GRADY PLACE SUBDIVISION

Revised for the January 19, 2017 meeting:

APPLICATION NUMBER 2 DATE January 19, 2017

DETAIL SITE PLAN

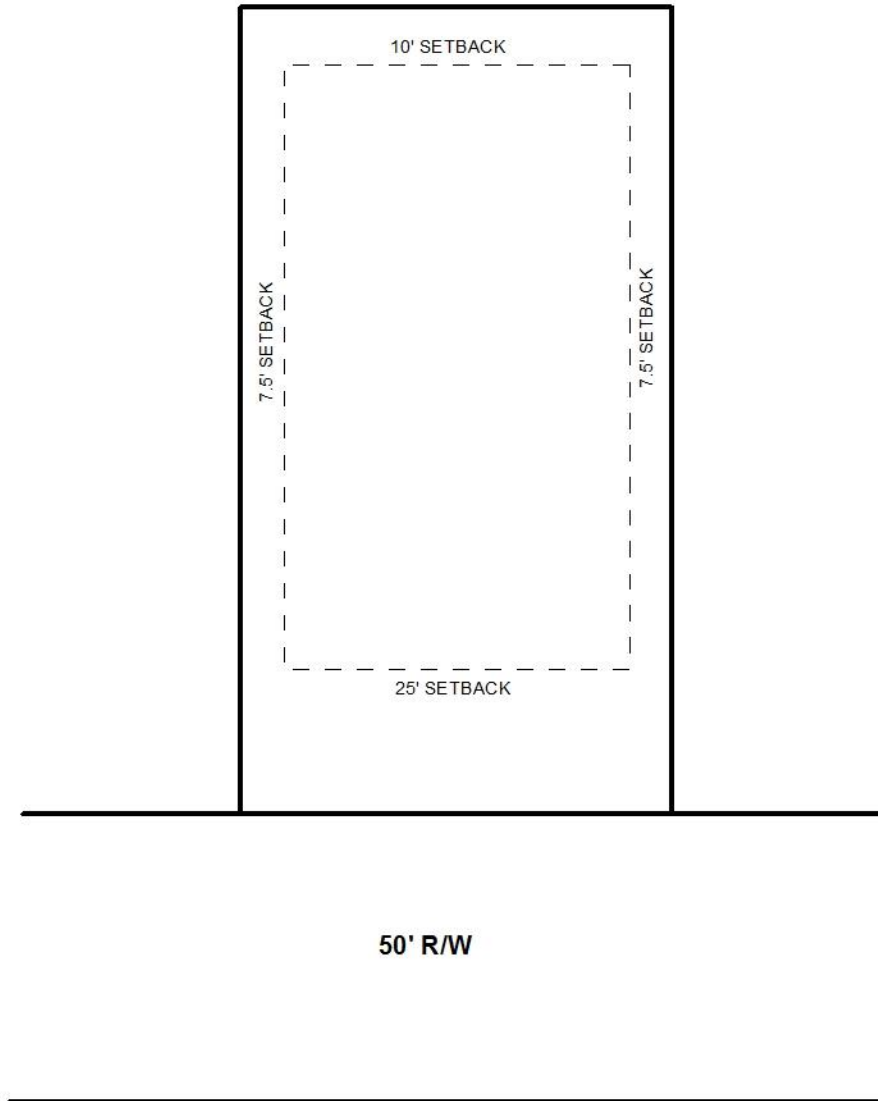
The site has frontage on Jeff Hamilton Road with a current right-of-way width of 80'. As this is a component of the Major Street Plan with a planned 100' right-of-way, dedication to provide 50' from the centerline of Jeff Hamilton Road would be required, and such is indicated on the preliminary plat. The plat indicates building setback lines on all lots, but no dimensions are given regarding the setbacks on the individual lots: a "typical" lot with a 25' front setback as well as side and rear setbacks is shown elsewhere on the plat. However, the plat should be revised to indicate a minimum building setback line of 25' along all street frontages, and all other building setback lines as shown on the "typical" lot diagram.

Access management is a concern along Jeff Hamilton Road; therefore, a note should be required on the Final Plat, if approved, stating that Lot 30 and the Common Area fronting Jeff Hamilton Road are denied access to Jeff Hamilton Road. Note # 4 on the preliminary plat erroneously limits the site to one curb cut to Snow Road. As the site does not front Snow Road, this portion of the note should be removed. The remainder of the note should be revised to limit each proposed lot and the Common Area fronting Jeff Hamilton Road to one curb cut each, with the size, location and design to be approved by Mobile County Engineering and conform to AASHTO standards. The interior Common Area does not have any street frontage or dedicated access. Therefore, the plat should be revised to indicate access for this Common Area.

The plat labels all lots and Common Areas with their area sizes. However, only the Common Areas are labeled in both square feet and acres. Therefore, the plat should be revised to label

each lot and Common Area with its size in both square feet and acres, or a table should be furnished on the Final Plat providing the same information.

Note # 5 on the preliminary plat should be retained stating that the maintenance of the Common Areas is the responsibility of the property owners. A 15' drainage easement is indicated extending from the proposed Magnolia Landing Loop to the large Common Area to the North. Note #9 on the plat states that no permanent structure can be placed in any easements. This note should be revised and retained on the Final Plat to state that no structure may be constructed or placed in any easement.

As submitted, the plat does not contain the entire Parcel R023402040000009.01. A portion in the Northeast corner of the parcel which extends to Jeff Hamilton Road is omitted on the plat. The plat should be revised to also include this portion of the parent parcel.

The Subdivision is proposed with 30 lots with only one point of access. Note # 14 on the plat references Appendix D of the 2009 International Fire Code (IFC) not requiring more than one access point for such. The plat also indicates the main street, Magnolia Landing Loop, to be approximately 1,273' long with a temporary turn-around at its East terminus. This indicates that future units of the Subdivision are proposed. Therefore, future proposed units should also be indicated as a composite so that an orderly traffic pattern and sufficient access points can be evaluated. Future phases should ensure that a second point of access is part of the next phase of development.

Since more lots and Common Areas are proposed, access management is a concern. Some notes on the plat should be revised to reflect such. Note 4 should be revised to simply state that each lot is limited to one curb cut, with the size, location and design to be approved by Mobile County Engineering and conform to AASHTO standards. Note 5 should be revised to state that Lot 30 and Common Area 1 in Phase One and Lots 31 through 35 in Phase Two are denied direct access to Jeff Hamilton Road. A note should be required on the Final Plat stating that Common Area 2 is limited to two curb cuts, with the size, location and design to be approved by Mobile County Engineering and conform to AASHTO standards. A note should also be required on the

There is a note on the plat stating that there is a 10' utility easement dedicated along all lot lines adjacent to rights-of-way; however, this is not graphically indicated on the plat. Therefore, the plat should be revised to illustrate all utility easements for the subdivision. The note stating that no structure may be constructed or place within any easement should be retained on the Final Plat.

Street frontage/curve dimensions are not furnished on all lots. Therefore, the plat should be revised to provide such data, either along the road frontages or on a table on the plat providing the same information.

The submitted preliminary plat for Phase One labels the remainder of the parent parcel R023402040000009.01 as Future Development. The submitted preliminary Master Plan plat showing Phase Two does not identify the remainder of Parcel R023402040000009.01 as Future Development. Therefore, the Master Plan plat should either be revised to label that remainder as Future Development or the remainder should be made a legal lot of record via a one-lot subdivision prior to signing the Final Plat for Phase Two.

- 1) retention of the dedication to provide 50' from the centerline of Jeff Hamilton Road;*

- 4) *revision of the plat to illustrate the 10' utility easement along all lot lines adjacent to rights-of-way as mentioned in the note on the preliminary plat, and any other easements proposed;*

- 5) *retention of the note on the Final Plat stating that no structure may be constructed or placed within any easement;*
- 6) *revision of the plat to furnish street frontage/curve and lot line dimensions on all lots, or the provision of a table on the Final Plat providing the same information;*

- 7) *placement of a note on the Final Plat stating that each lot is limited to one curb cut, with the size, location and design to be approved by Mobile County Engineering and conform to AASHTO standards;*

- 8) *placement of a note on the Final Plat stating that Lot 30 and Common Area 1 in Phase One and Lots 31 through 35 in Phase Two are denied direct access to Jeff Hamilton Road;*

- 9) *placement of a note on the Final Plat stating that Common Area 1 and Common Area 3 are limited to one curb cut each, and Common Area 2 is limited to two curb cuts, with the size, location and design to be approved by Mobile County Engineering and conform to AASHTO standards;*

- 14) *submittal of a revised Master Plan plat to account for the remainder of Parcel R023402040000009.01 as Future Development or the approval of that portion as a one-lot subdivision prior to the signing of the Final Plat for Phase Two;*

TYPICAL LOT SETBACKS

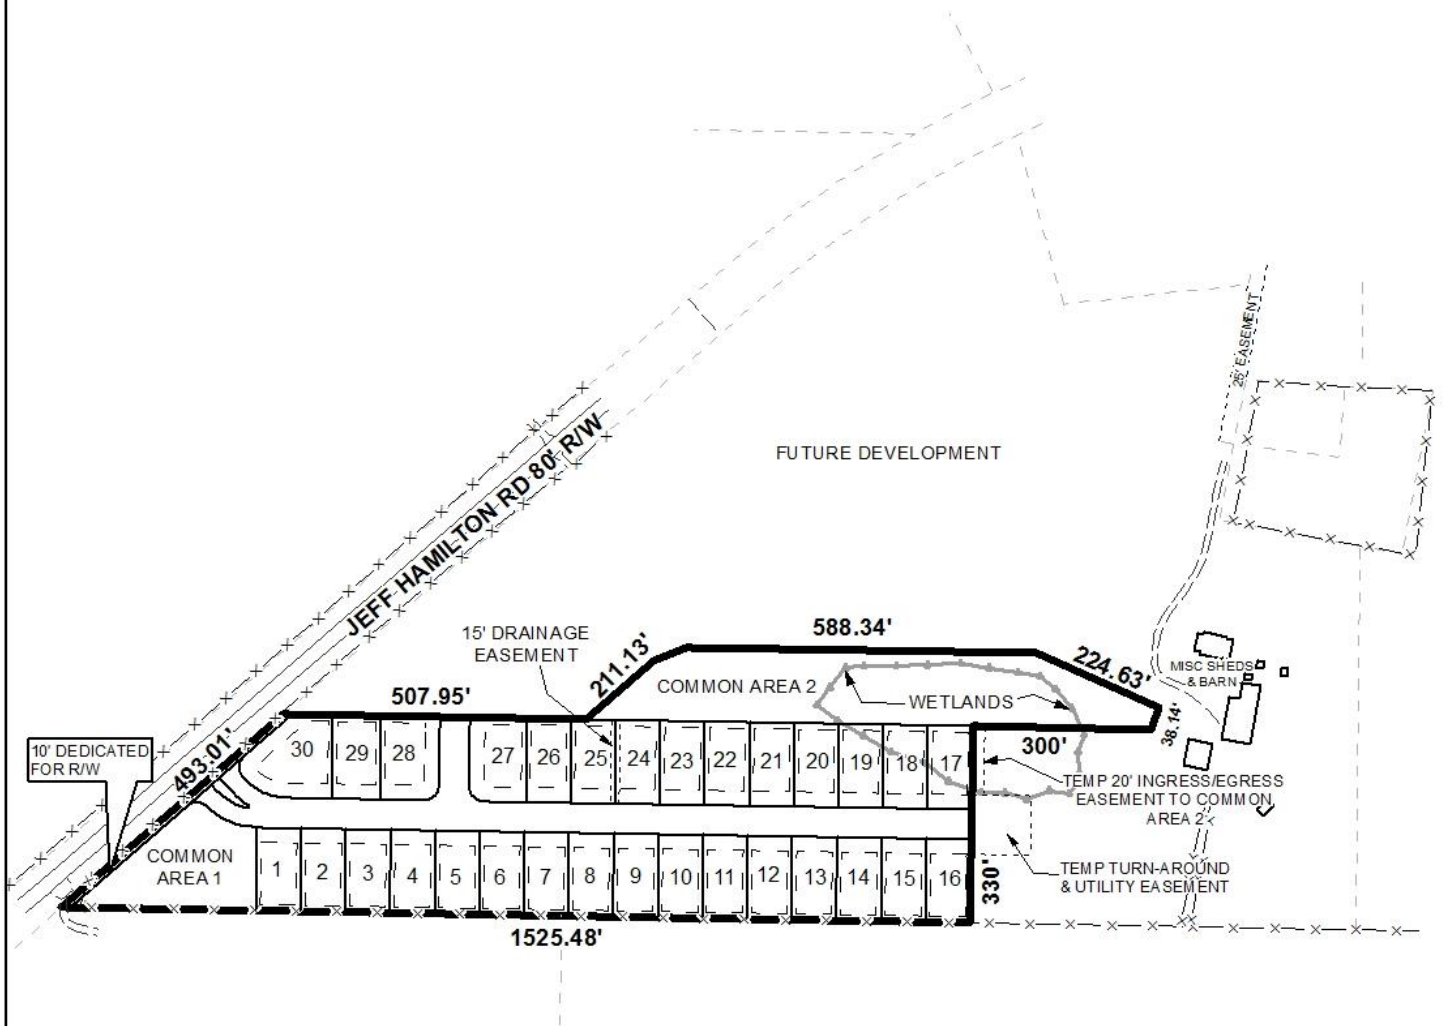
The plat contains a diagram of typical lot setbacks. As the setbacks indicated would apply to interior lots only, the diagram should have a note stating such and that all corner lots are to have 25' setbacks along all street frontages.

- 2) *retention of the 25' minimum building setback line along all street frontages;*
- 3) *placement of a note on the typical lot setback diagram stating that all corner lots have a 25' minimum building setback line along all street frontages;*
